Project Title: HWY SR 523 - MP 0.78 to 1.11 WSDOT Region: WIN:

DECEMBER 2021 PROPOSED BASIN EXHIBIT 2

Tc = 5.00 C = 0.90 I = 2.39 m= 5.62 Project Name: SR 523 & I-5 INTERCHANGE IMPROVEMENTS
Project #: 16242
S.R.: 523
Designed By: JP
Date: 1/5/2021

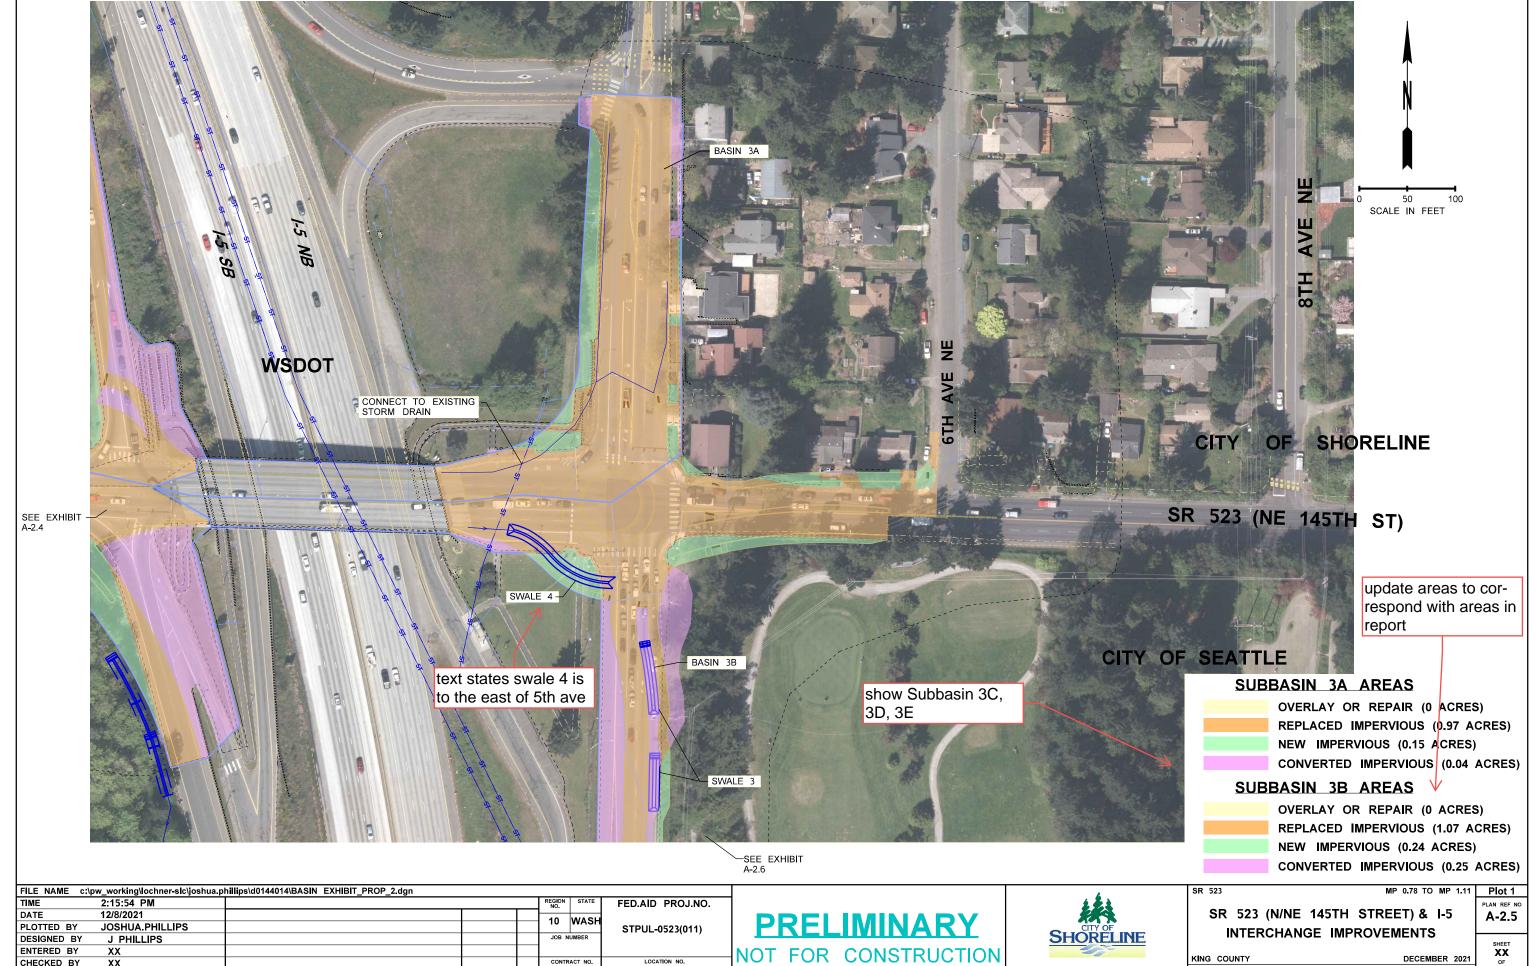
reverted impervious areas should not be included here. revise number for all new impervious areas.

/													
	update for 3c, 3d, & 3e	should be zero	0											
		Is for Project 46,907 3	36,742 10,165	162,808	0	10,165	0					10,165	0
